## Groundwater Application Review Summary Form

Application # G- 18350-RR

**To:** Kristopher Byrd, Well Construction and Compliance Section Manager  
**From:** Joel Jeffery, Well Construction Program Coordinator  
**Subject:** Review of Water Right Application G-18350  
**Date:** September 12, 2018

SUBJECT: Application G- 18350 Supersedes review of September 29, 2016  
Date of Review(s)

**Partially penetrating stream with streambed resistance (Hunt, 1999)**

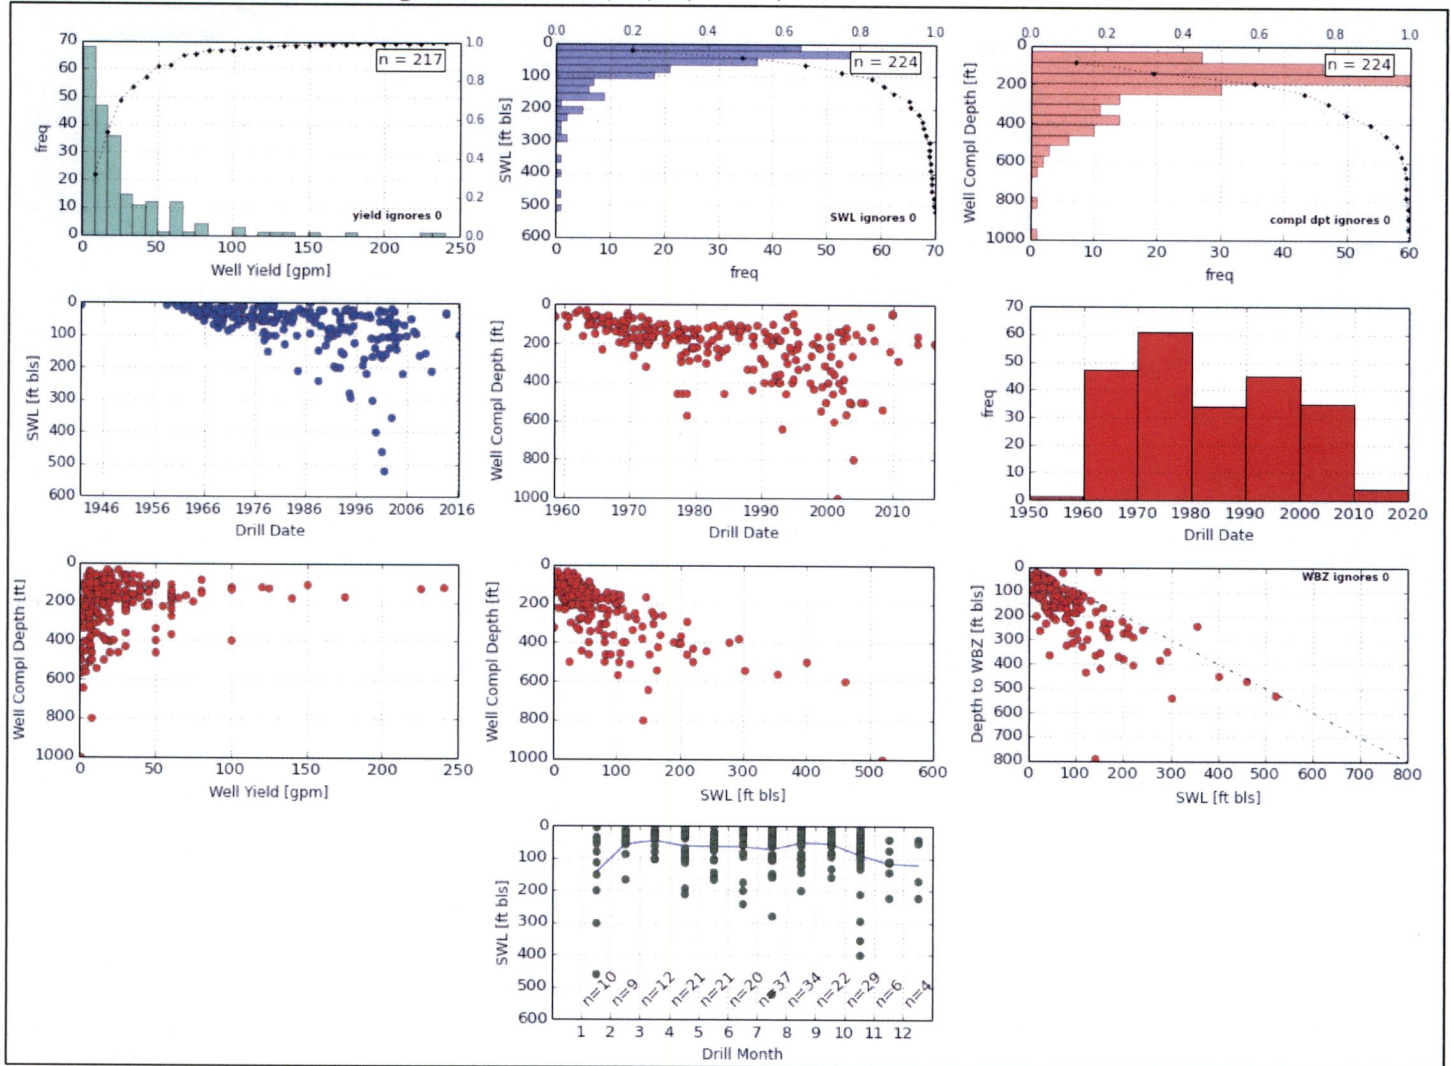
**Comments:** Interference with surface water was estimated using the Hunt (1999) stream-depletion model run through the USGS Michigan Water Science Center web-based version. The model was run using parameter values expected for this type of geology. The model input page is attached and the website can be found at: <http://mi.water.usgs.gov/software/groundwater/CalculateWell/index.html>

<sup>A</sup> Only Well #6 (JACK 30158) was evaluated for PSI because it is the closest to the impacted surface water. Interference is inversely-proportional to distance so all other wells will have less interference with surface water
